# Access Compliance Report

## Public Rights-of-Way

Intersection ID: 44218	Main Street: ATHERTON_MILL_RD	Cross Street: ROZZELLES_LANDING_DR	Location: SE
ADA ID: E0F4FB652D17	Ramp Type: PerpDiag	Initial Pass/Fail: Fail	Overall Compliance: No
Codes/Mitigation Info/Possible Solution		Field Measurements/Component Compliance	
Severity Score: 8.75

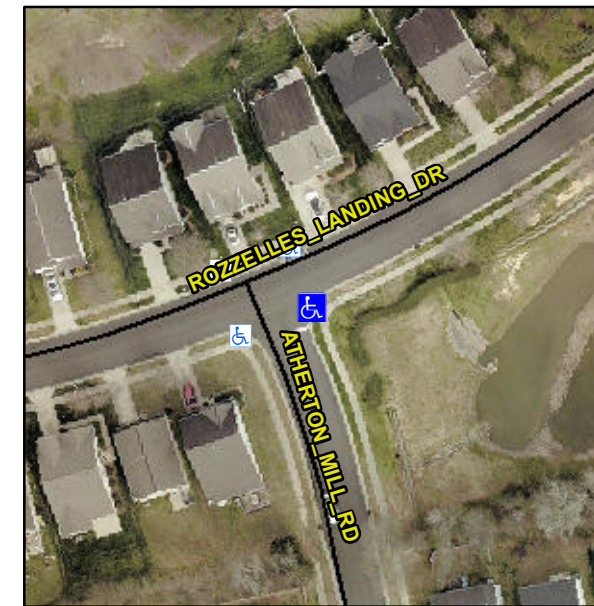
**Not Found, R304.5.1**

Compliance	Description	Data	Compliance	Description	Data
N/A	Ramp Length (in)	52.0	Yes	Ramp Slope (%)	5.2
No	Ramp Width (in)	38.0	Yes	Ramp XSlope (%)	0.2
N/A	Flare Type LT	N/A	N/A	Flare Type RT	N/A
N/A	Flare Slope LT (%)	N/A	N/A	Flare Slope RT (%)	N/A
N/A	Flare Traversable LT?	N/A	N/A	Flare Traversable RT?	N/A
N/A	Landing Length (in)	N/A	N/A	DWS Provided?	N/A
N/A	Landing Width (in)	N/A	N/A	DWS Contrast?	N/A
N/A	Landing Slope (%)	N/A	N/A	DWS Length (in)	N/A
N/A	Landing X Slope (%)	N/A	N/A	DWS Full Width?	N/A
N/A	Landing Curb? (Y/N)	N/A	N/A	DWS Offset (in)	N/A
N/A	Shared Landing?	N/A			
N/A	Gutter Ponding?	N/A	N/A	Gutter Slope (%)	N/A
N/A	Gutter Lip Ht (in)	N/A	N/A	Gutter X Slope (%)	N/A
N/A	Painted X Walk1?	No	N/A	Painted X Walk2?	No
	X Walk 1 Direction	To N		X Walk 2 Direction	To W
N/A	X Walk 1 Width (in)	N/A	N/A	X Walk 2 Width (in)	N/A
	X Walk 1 Slope (%)	4.5		X Walk 2 Slope (%)	3.7
	X Walk 1 X Slope (%)	2.9		X Walk 2 X Slope (%)	3.5

**Remove & Replace Curb Ramp With Two New Directional Ramps or Equivalent.**
